# Kansas City Water Works.

Commission of Engineers,

# Report of Commission of Water Works Engineers.

*February 5th, 1902.*

PLAN NO 4.

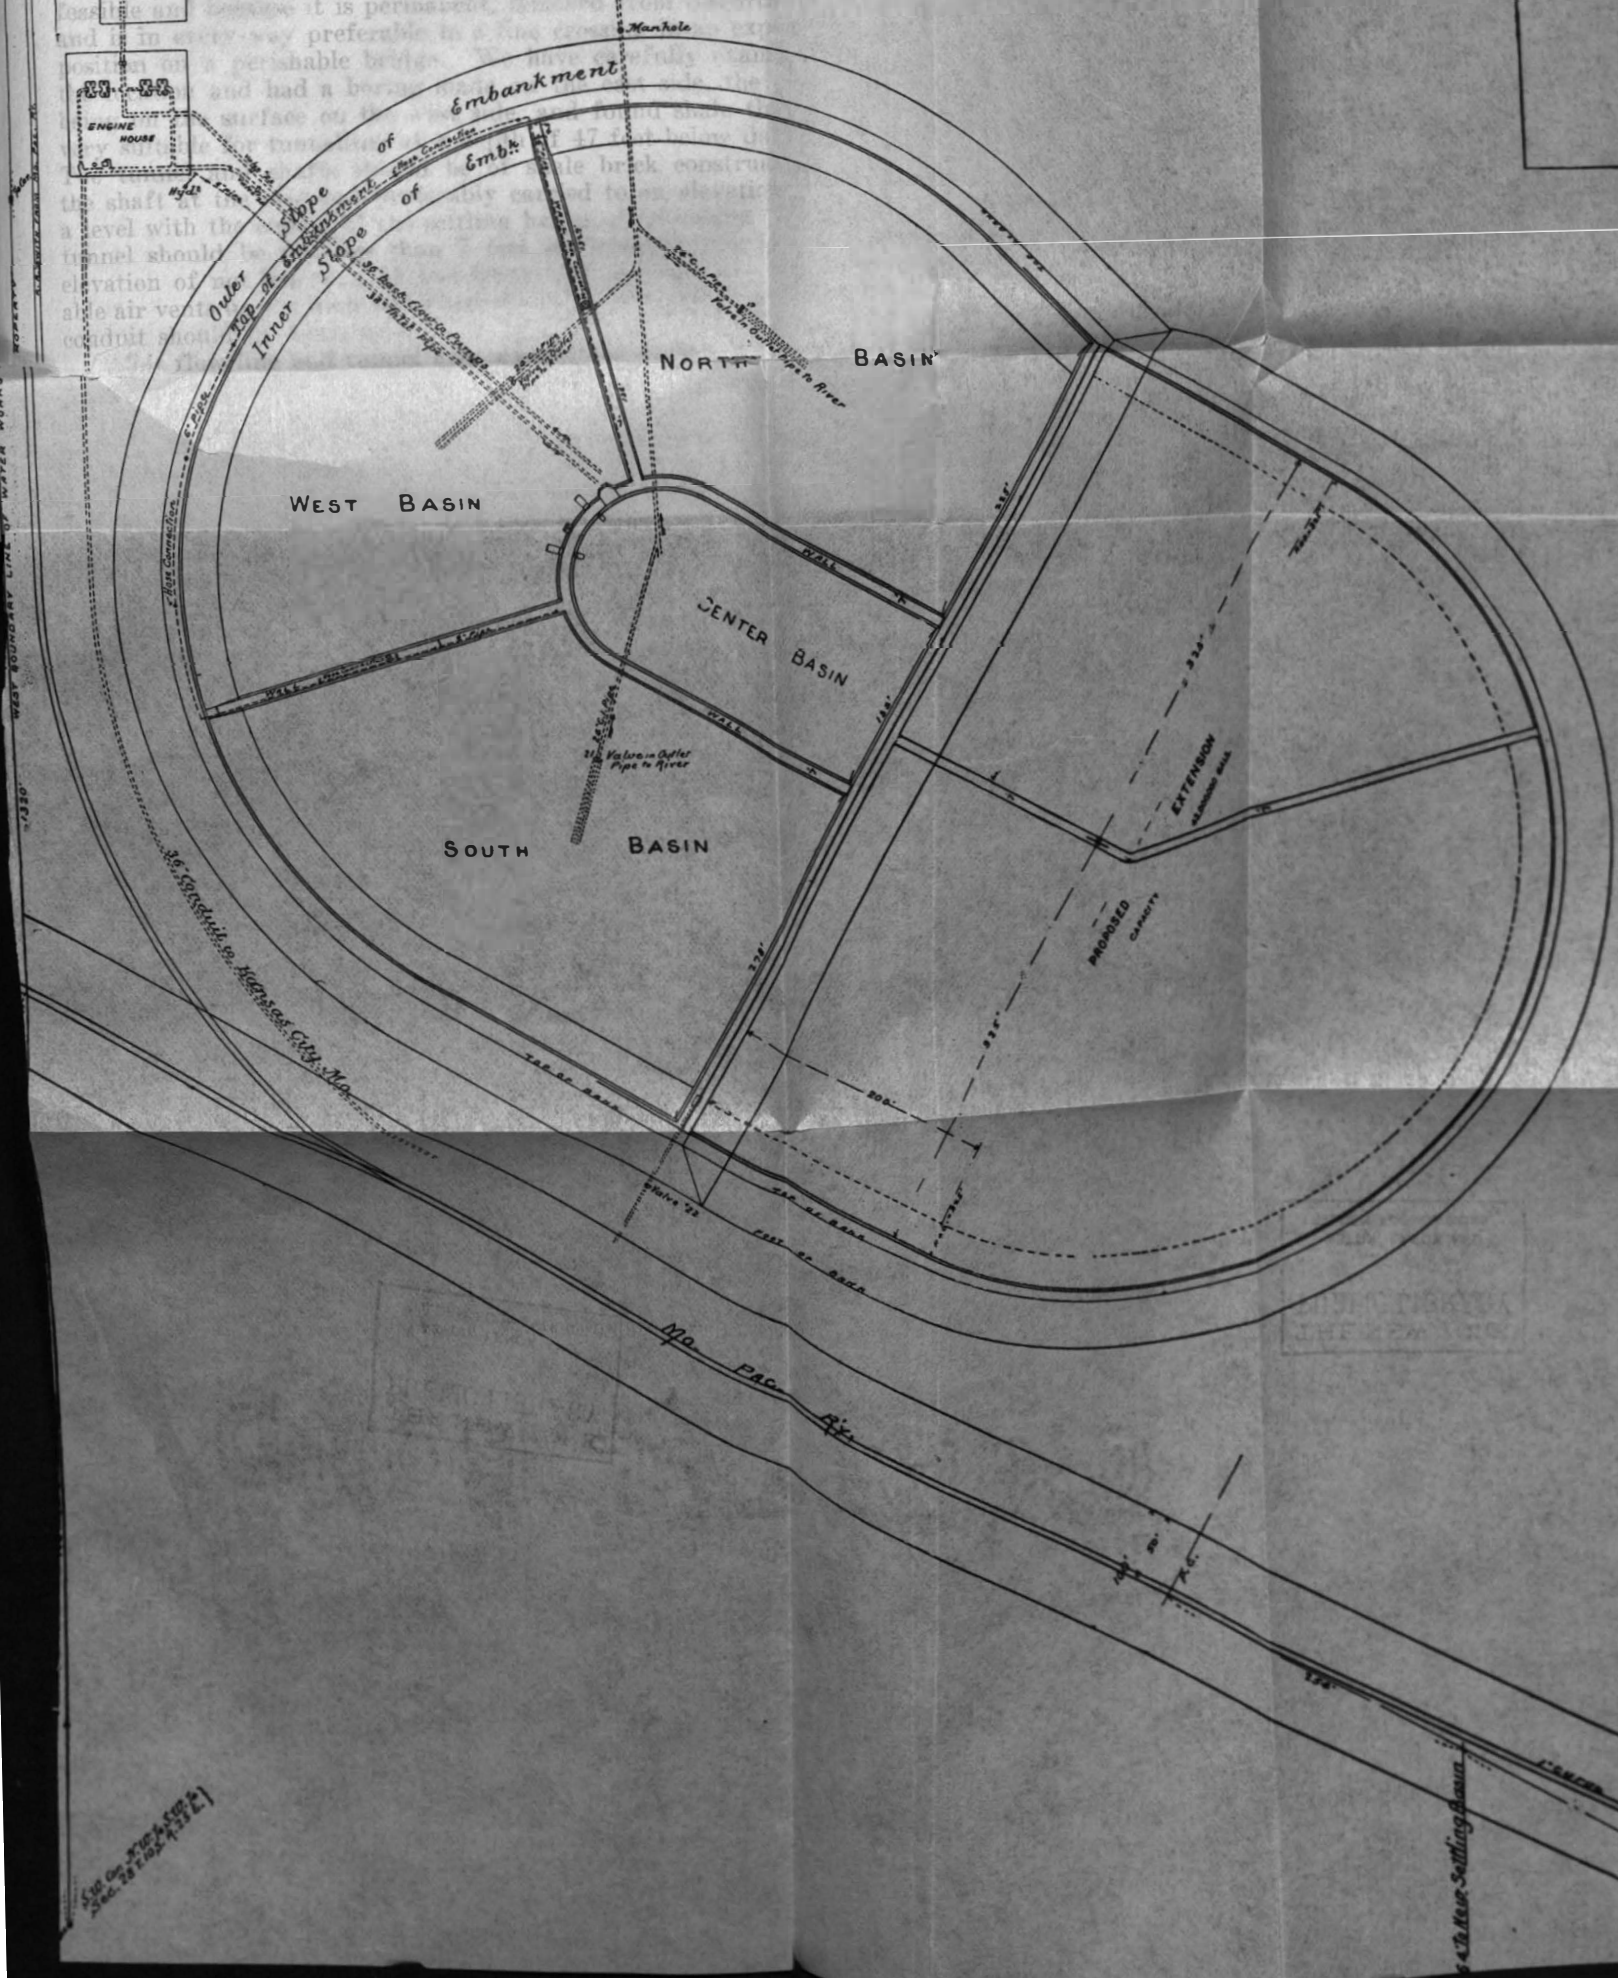
Since the installation of this method the quality of the water delivered at Turkey Creek has been satisfactory except during extreme high water. It is very probable that with the present method of sedimentation these basins will be of sufficient capacity for some years to come. At some time after the inauguration of a new flow line it may become necessary to increase the capacity of these basins by additional basins as shown on Plan No. 4, which will have a capacity of 42,000,000 gallons, giving a combined total capacity of 87,000,000 gallons.

# PLAN № 3

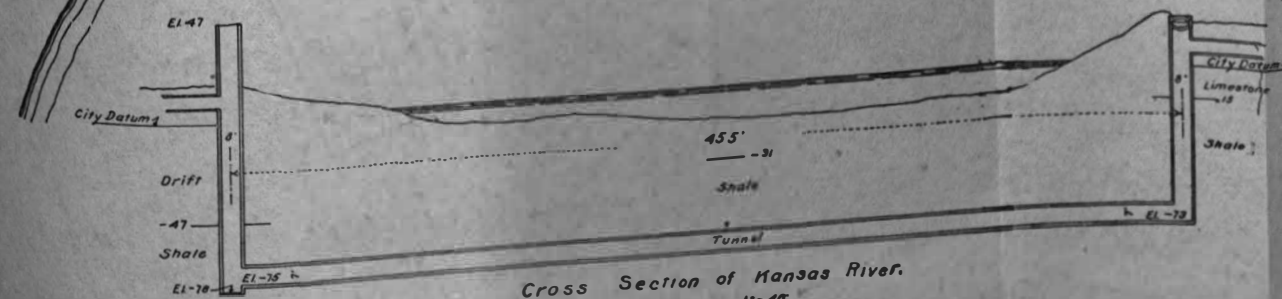
A third route proposed was from the present end of the new 30-inch line at the crossing of 12th and Bell Streets, in a direct line to and along James Street to the City's right of way across the Metropolitan Water Company's property and along this to the end of the 36-inch pipe.

and \$17,232 less than the cost of the second route. This third route presents no question as to the right of way along its entire length, nor does it present any special difficulties of construction which are greater than those of either of the other two lines.

PLAN NO. 7.

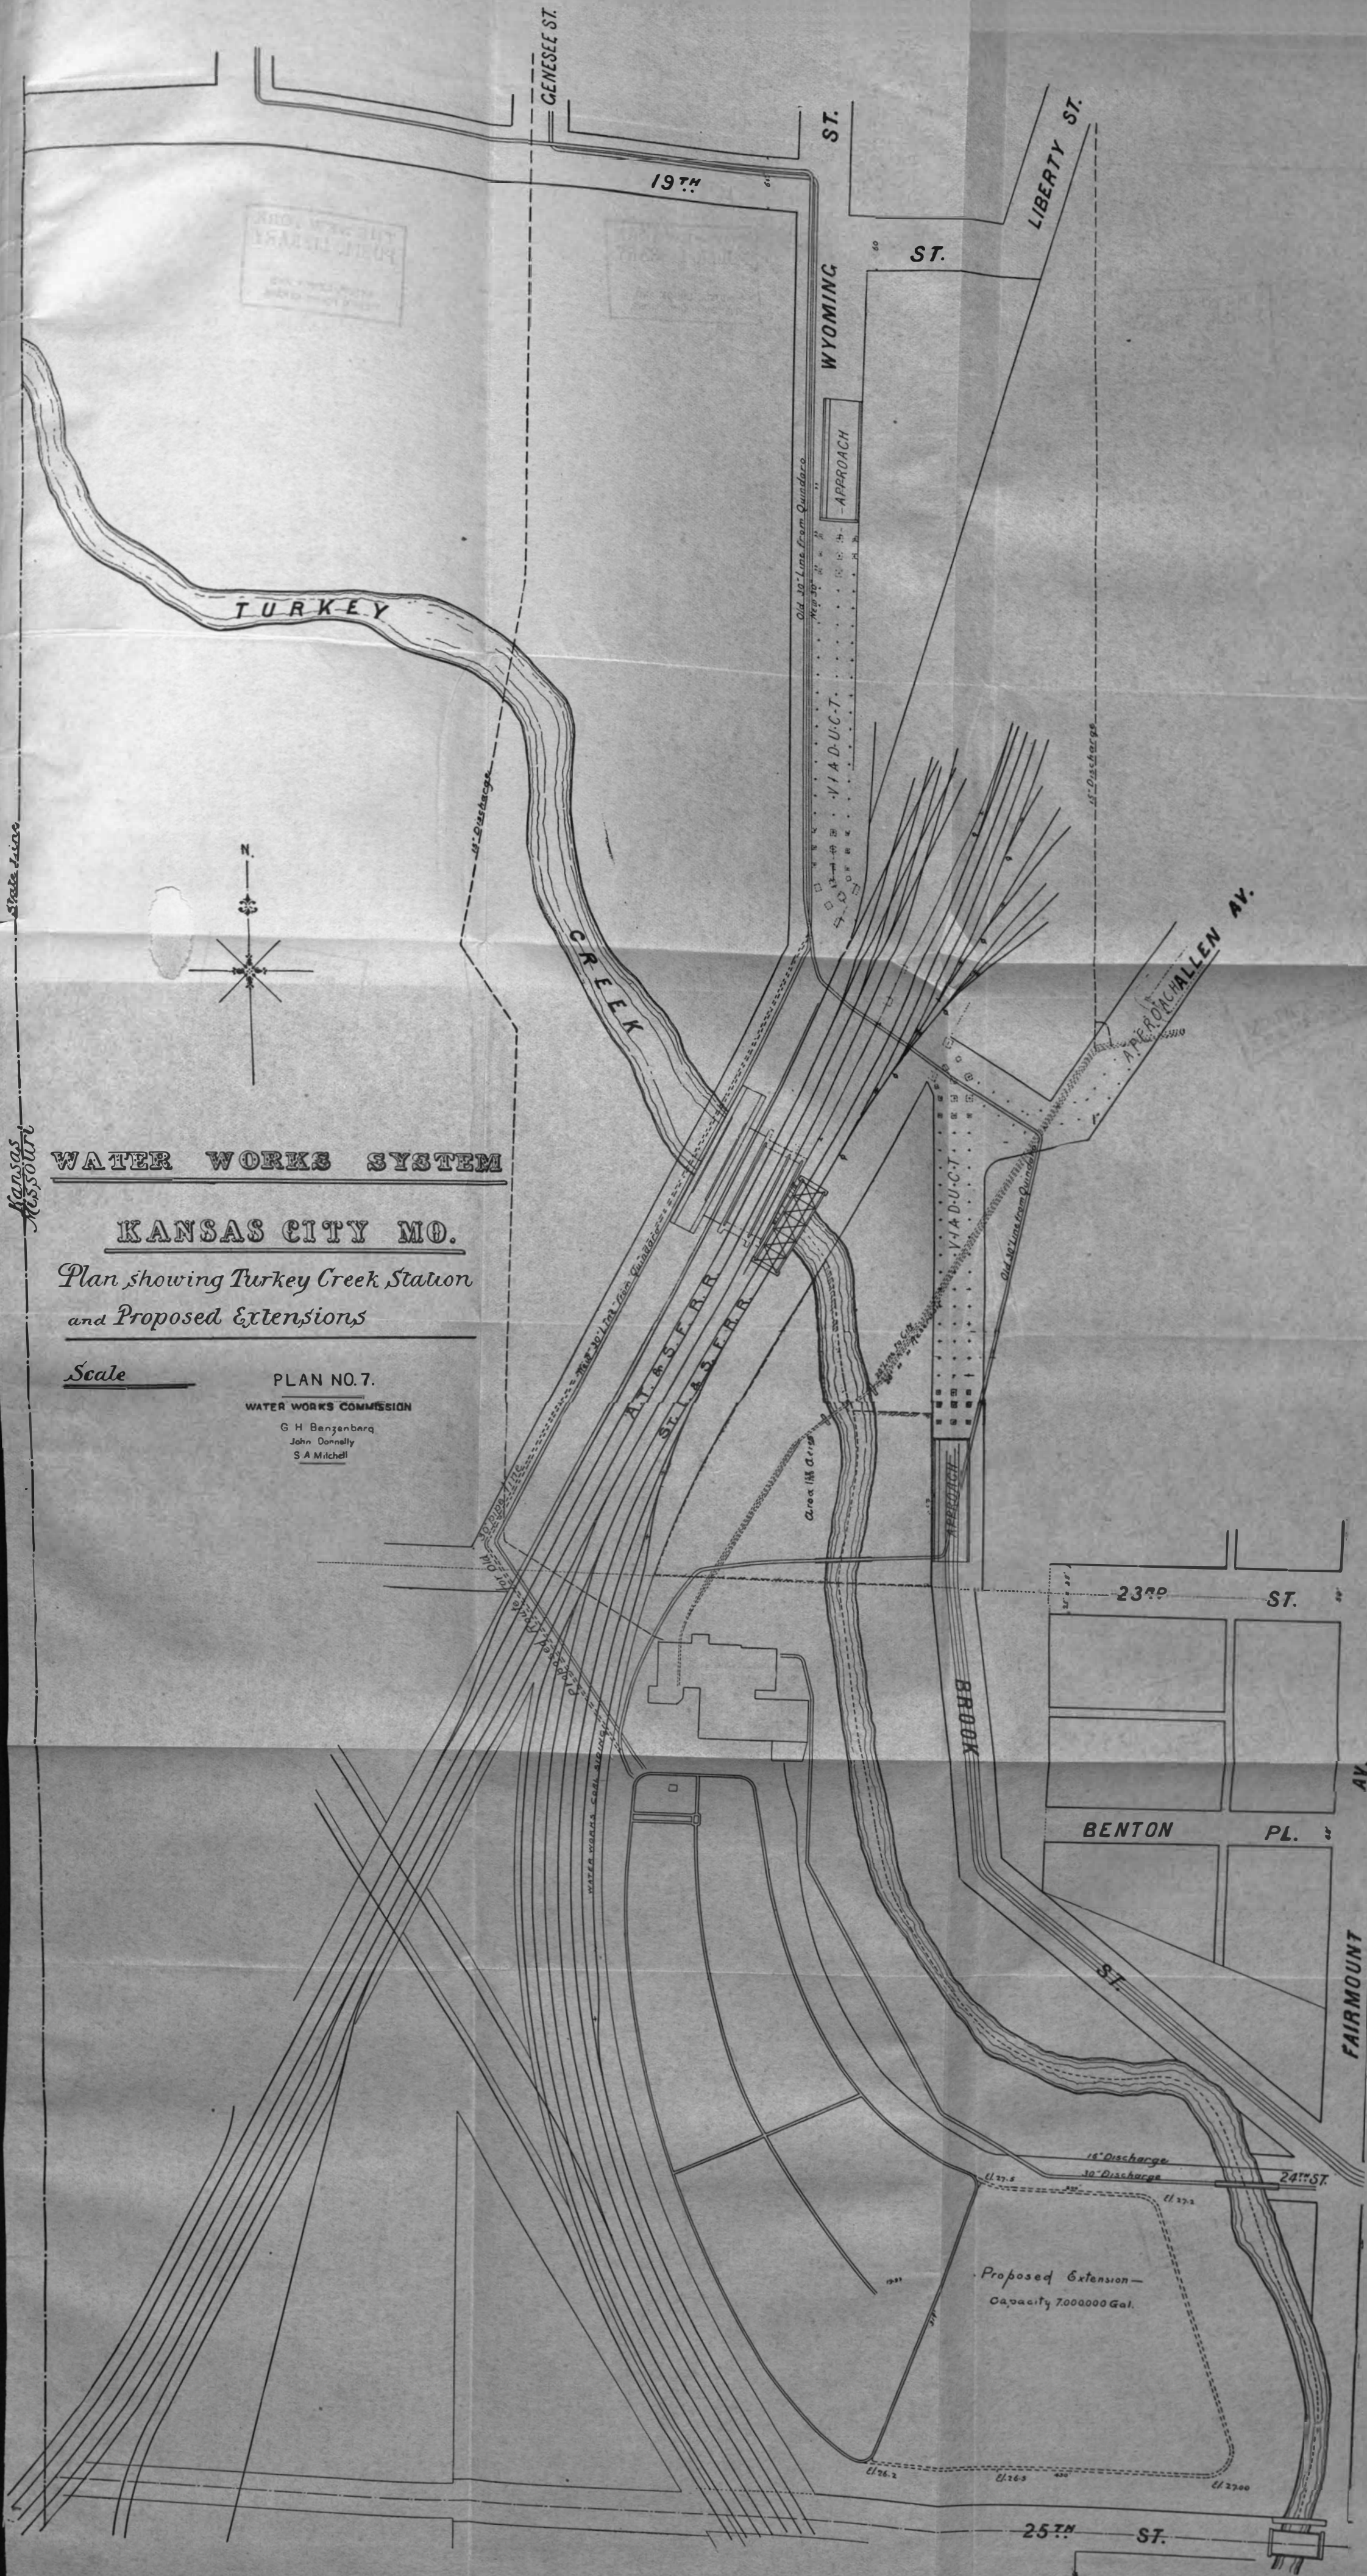
A proposed addition to this basin shown on Plan No. 7 and constructed similar to present basins, would give an additional storage capacity of 8 million gallons, making a total of 18 million. No greater quantity can be secured without an entire reconstruction of these basins, the cost of which would not justify the outlay. Any raising of the reservoir walls will diminish the head under which water is delivered from Quindaro, and therefore diminish such delivery. It might be advisable to construct this addition at some time in the future, but its present undertaking is hardly justifiable, in view of other pressing demands, and the fact that it adds but one-half day's supply at our present rate of consumption, especially when the construction of a new flow line from Quindaro, with its ample capacity, will obviate the necessity of additional storage at Turkey Creek.

We are of the opinion that additional ground should be secured for the enlargement and reconstruction of the pumping station as indicated in our answer to question No. 4, and as shown on Plan No. 7, and as there is but this limited piece of ground which is at all available, and as it is necessary to the bringing in of new and rearranging of the old lines of pipe around this pumping station, we would recommend that the city secure this strip of land as soon as possible.
